25th October 2019
Our Ref. 190065
Council Ref: DA2019/0762
RFS Ref: D19/2648 DA19080619905 CC

**Re: RFS REQUEST FOR FURTHER INFORMATION
131 THOMPSON STREET, SCOTLAND ISLAND**

This Statement is provided in response to the Northern Beaches Council Natural Environment Referral Response – Biodiversity for DA2019/0762.

Image 01: Extract from the attached Overlay of the subject area

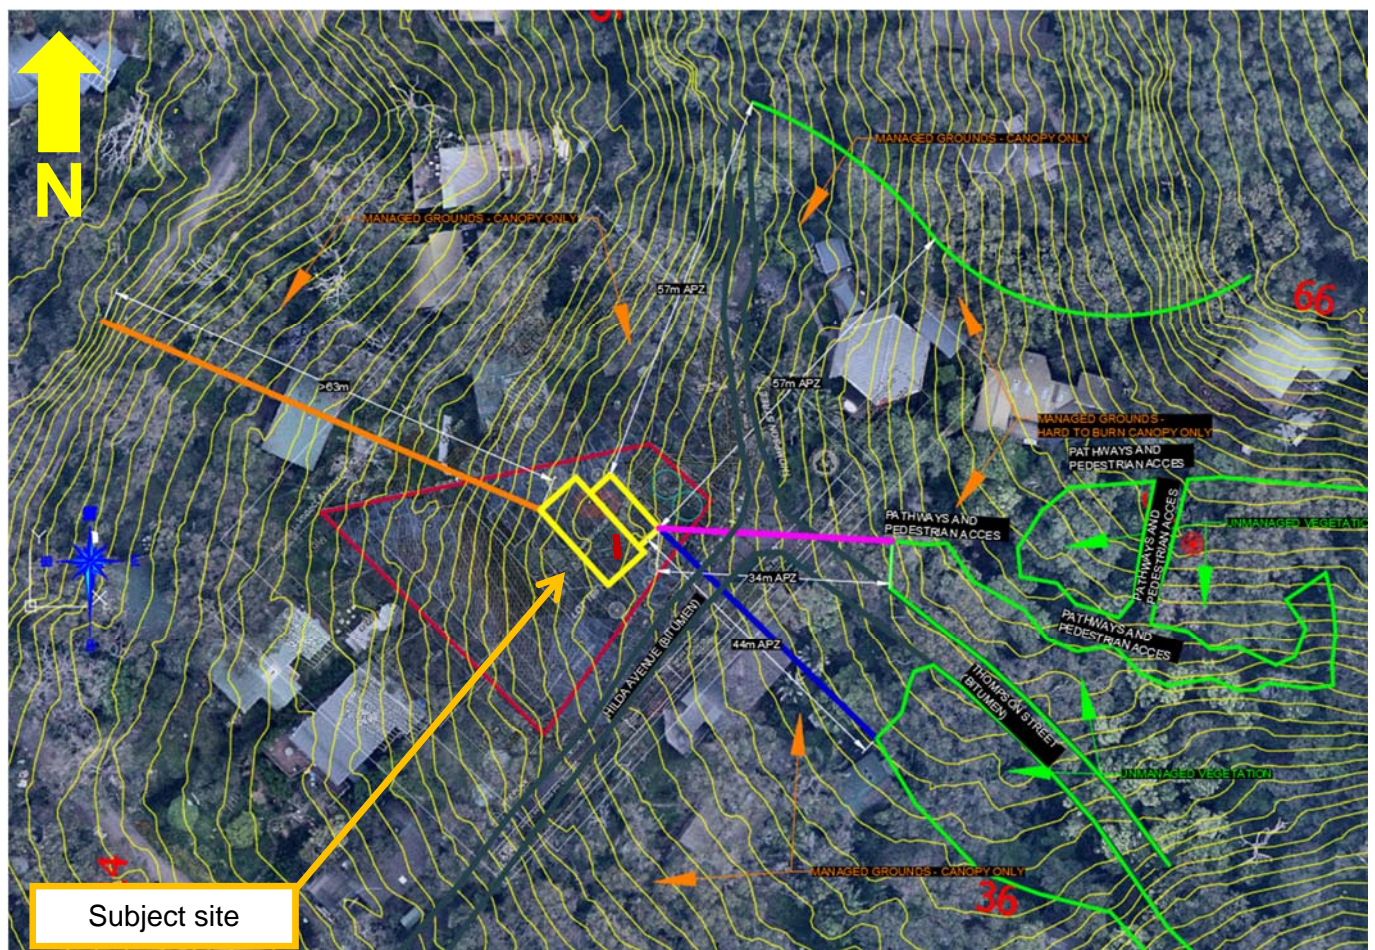
- *The impact of the existing connecting tree canopy, located over and extending up from the south across the subject allotment and up to the ridge line, on the radiant heat exposure to the proposed footprint.*

The vegetation within neighbouring allotments to the southeast is broken by built upon areas and landscaping which does not provide for continuous fire runs toward the subject site. Furthermore the subject site is separated from any perceived hazard by the formed Thompson Street to the north & northeast and Hilda Avenue to the east which provide for a further separation of fuels and canopy.

The presence of these steep up slopes would be expected to inhibit the development of a crown fire from this aspect with the ability of this vegetation to sustain a crown fire is considered to be negligible.

The landscaped areas within the neighbouring allotments to the east and southeast consist of weeds and exotics and are not considered to be conducive to the spread of fire and the hazard beyond (east) of HN74 Thompson Street providing the highest hazard to the subject site.

A photo montage is attached to this statement highlighting the areas of managed vegetation and canopy separation.

Aerial view and photographic montage of
131 Thompson Street, Scotland Island

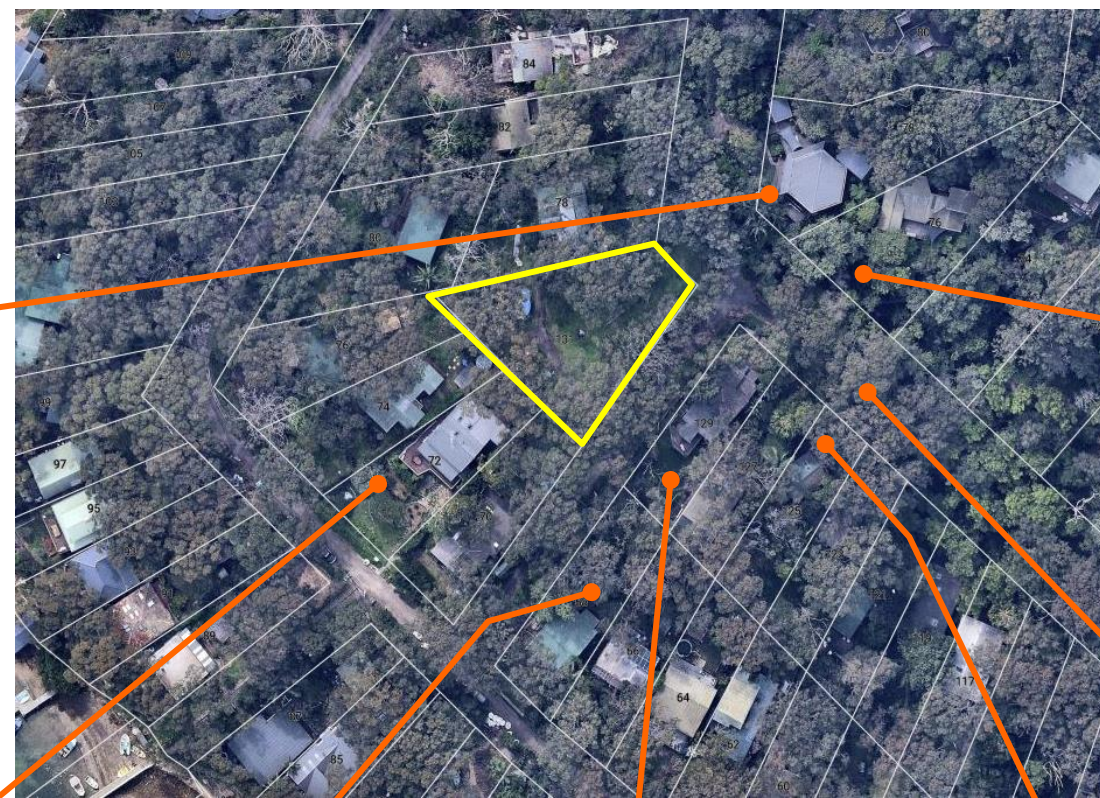
- Supporting photographic information detailing the extent of the asset protection zones on the surrounding allotments*

Photo montage and Overlay attached.
